Access Compliance Report Public Rights-of-Way (Curb Ramps)

Intersection ID: 2684 Main Street: CARDINAL_POINT_RD Cross Street: SUMMERGOLD_WY Location: SW

ADA ID: 705D0C8E9EFD Ramp Type: Perp Initial Pass/Fail: Pass Overall Compliance: No Severity Score: 0

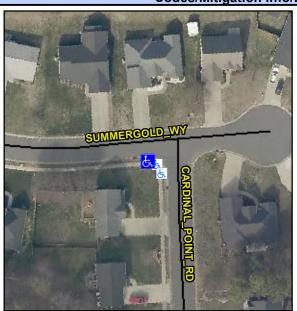
n ossible solution		i icia ivic	
Possible Solutions:	Compl	Compliance Description	
Remove & Replace Entire Ramp.	N/A	I/A Ramp Length (in)	
·	Yes	Ramp Width (in)	
	N/A	Flare Type LT	
	N/A	Flare Slope LT (%)	
	N/A	Flare Traversable LT	
	Yes	Landing Length (in)	
Surveyor Notes:	Yes	Landing Width (in)	
N/A	Yes	Landing Slope (%)	
	Yes	Landing X Slope (%)	
	N/A	Landing Curb? (Y/N)	
	N/A	Shared Landing?	
PROW/ADA:	Yes	Gutter Ponding?	
Not Found, R305.2	Yes	s Gutter Lip Ht (in)	
	N/A	Painted X Walk1?	
		X Walk 1 Direction	
	N/A	X Walk 1 Width (in)	
		X Walk 1 Slope (%)	
		X Walk 1 X Slope (%	
	N/A	Ramp inside XWalk1	
		Road Slone (%)

N/A	Ramp Length (in)	48.0	Yes	Ramp Slope (%)	5.5
Yes	Ramp Width (in)	48.0	Yes	Ramp XSlope (%)	1.5
N/A	Flare Type LT	Sloped	N/A	Flare Type RT	N/A
N/A	Flare Slope LT (%)	5.2	Yes	Flare Slope RT (%)	4.2
N/A	Flare Traversable LT?	Yes	N/A	Flare Traversable RT?	Yes
Yes	Landing Length (in)	48.0	Yes	DWS Provided?	Yes
Yes	Landing Width (in)	48.0	Yes	DWS Contrast?	Yes
Yes	Landing Slope (%)	1.6	Yes	DWS Length (in)	25.5
Yes	Landing X Slope (%)	1.1	Yes	DWS Full Width?	Yes
N/A	Landing Curb? (Y/N)	No	No	DWS Offset (in)	3.5
N/A	Shared Landing?	No			
Yes	Gutter Ponding?	No	Yes	Gutter Slope (%)	0.4
Yes	Gutter Lip Ht (in)	0.0	Yes	Gutter X Slope (%)	1.4
N/A	Painted X Walk1?	No	N/A	Painted X Walk2?	N/A
	X Walk 1 Direction	To N		X Walk 2 Direction	N/A
N/A	X Walk 1 Width (in)	N/A	N/A	X Walk 2 Width (in)	N/A
	X Walk 1 Slope (%)	4.5		X Walk 2 Slope (%)	N/A
	X Walk 1 X Slope (%)	0.2		X Walk 2 X Slope (%)	N/A
N/A	Ramp inside XWalk1?	N/A	N/A	Ramp inside XWalk2?	N/A
